UNITED STATES PATENT AND TRADEMARK OFFICE

APPLICATION NO.	FILING DATE	FIRST NAMED INVENTOR	ATTORNEY DOCKET NO.	CONFIRMATION NO.
09/811,506	03/20/2001	Mitsuharu Nakamura	040894-5647	8902

# Office Action Summary

## DETAILED ACTION

FIG. 5

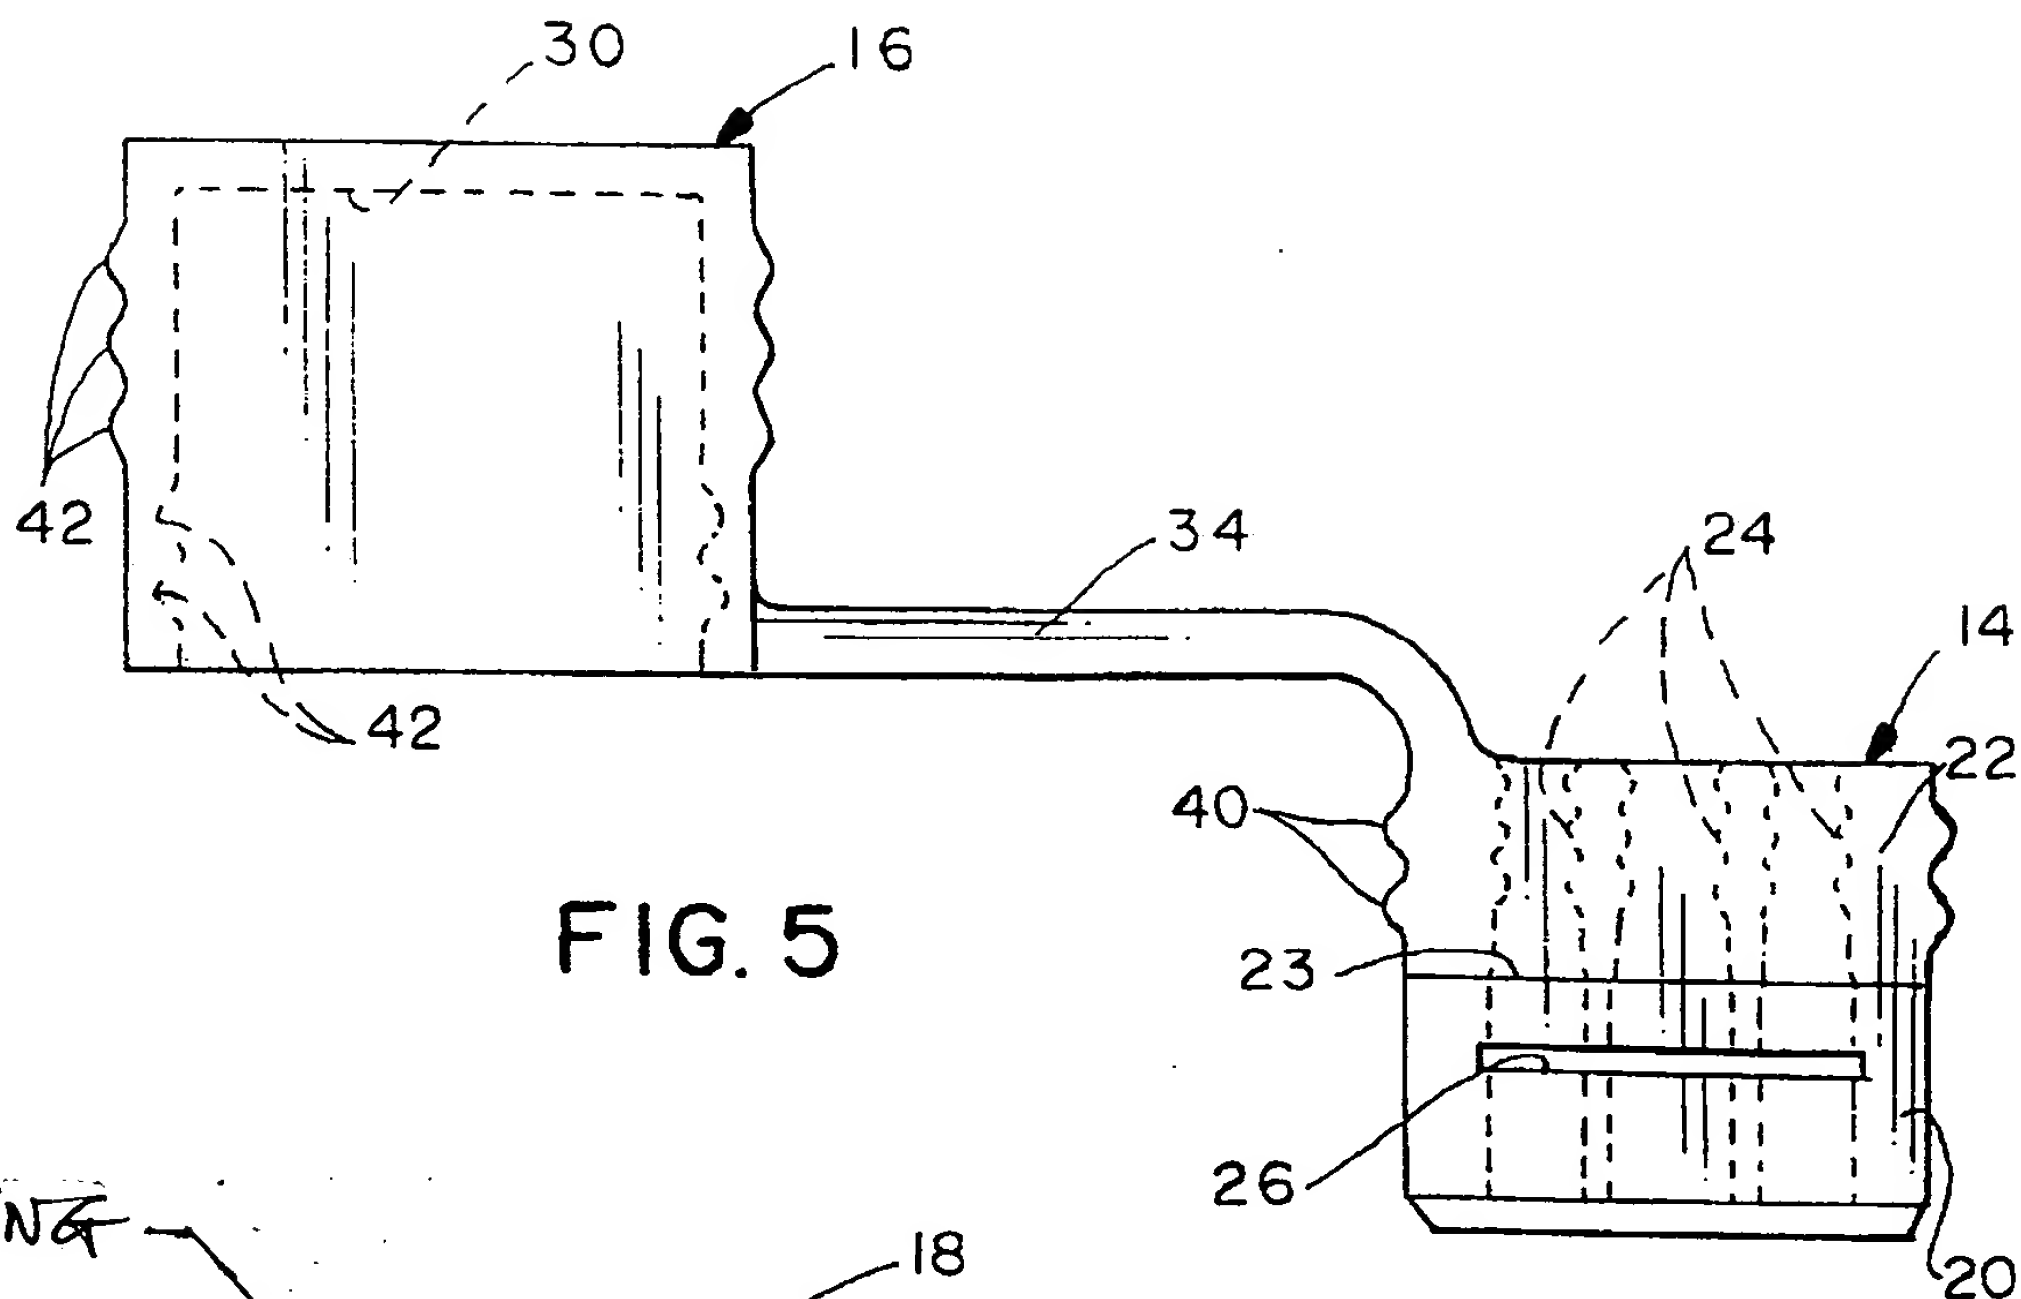
Marshall et al. discloses a dustproof cover assembly [figures 4-5] comprising:

- a cap-shape cover [16];
- a packing protecting portion [see attachment] extending from an end of an opening of a peripheral wall of the cover in a continual longitudinal direction;

- the cover is fitted to a connector [12, 14] so as to cover a front end fitting surface of the connector and the packing protecting portion covers a packing [see attachment] exposed around an outer peripheral portion of the connector; and

FIG.3

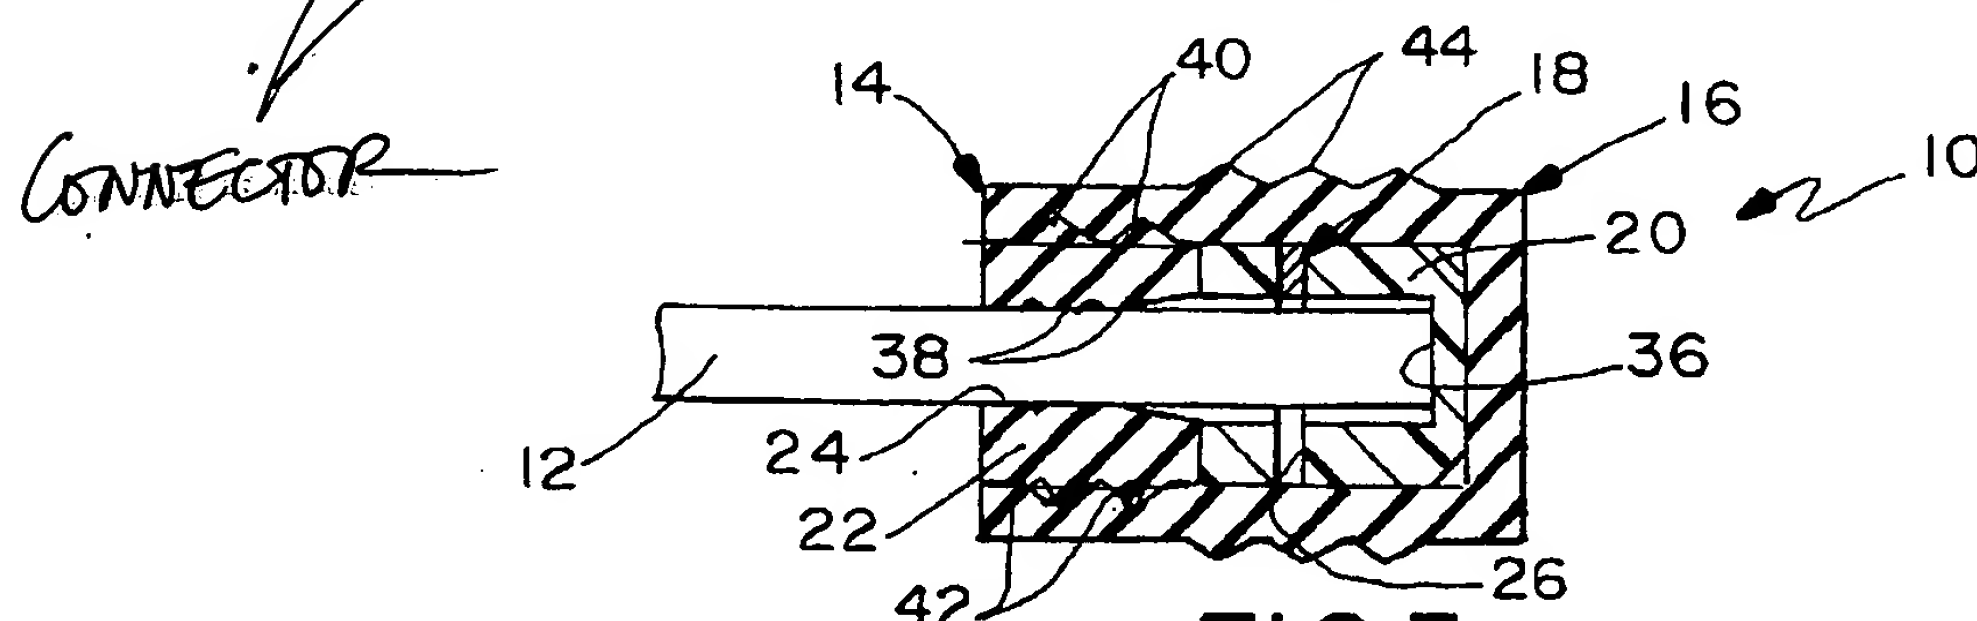
- an inner peripheral surface of the packing protecting portion is formed in such a manner as to be brought into contact with the packing [figure 3].
